Zenair Europe

Service Letter

S.L. Number:	ZE-2009-01
Date of issue:	June 1, 2009
Subject:	Verification of the proper installation of the “Flap Stops” (Part N° 6S3-1)
Affected Models:	All Zenair Zodiac CH 601XL/CH 650 (ULM and Homebuilt Models).
Serial Number(s)	All
Manufactured by:	Czech Aircraft Works (CZAW) and others.
Purpose:	The purpose of this S.L. is to ensure that all affected models are only flown when “Flap Stops” are installed.
Directed Action(s):	<p>a) Before the next flight, inspect the outboard area of the flap gaps on the top surface of each wing, to establish that the “Flap Stops” have been properly installed (see illustrations on page 2).</p> <p>b) When properly installed, the flaps come to rest against the “Flap Stops” when in the “up” (retracted) position. There should be no free-play at the trailing edge of the flaps when flaps are in the “up” position (snug against the Flap Stop).</p> <p>c) If not installed (see photo below), obtain and install the missing parts according to this S.L. before the next flight.</p> <div data-bbox="764 1272 1212 1536" data-label="Image"> </div>

Left flap shown in “down” position

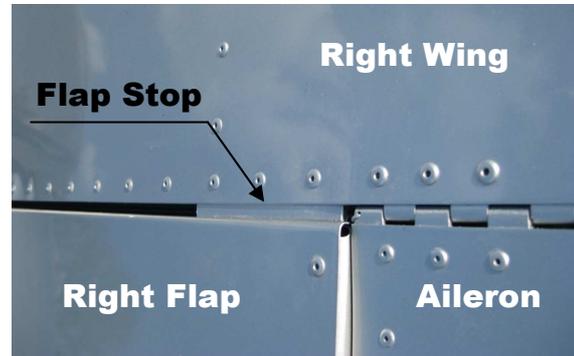
1) When in the “up” position, the flap must rest against a plastic “flap stop” (see photos below). Both left and right flaps must be touching the stops when flaps are retracted (“up”).

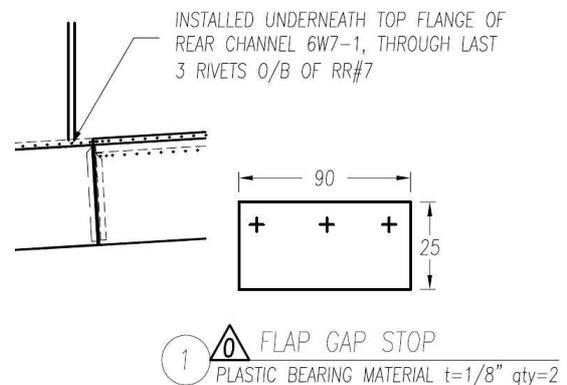
2) There should be no free-play in the flaps when they are in the “up” position (test by applying light up-then-down pressure to the trailing edge). When flap stop (6S3-1) is installed as illustrated, no further action is necessary.

3) If Flap Stops are missing, order and install the parts by first drilling out the three corresponding rivets at trailing edge; position the plastic stops so that flaps just touch them in the up position and tape in place. Use existing rivet holes to position drill bit (#20 or 4mm) and drill through plastic. Remove tape and any burrs, rivet in place with three A5 Avex rivets or equivalent. Apply desired finish. Caution: If using Zenair-supplied rivets, the correct riveter-head must be used on the riveting tool!
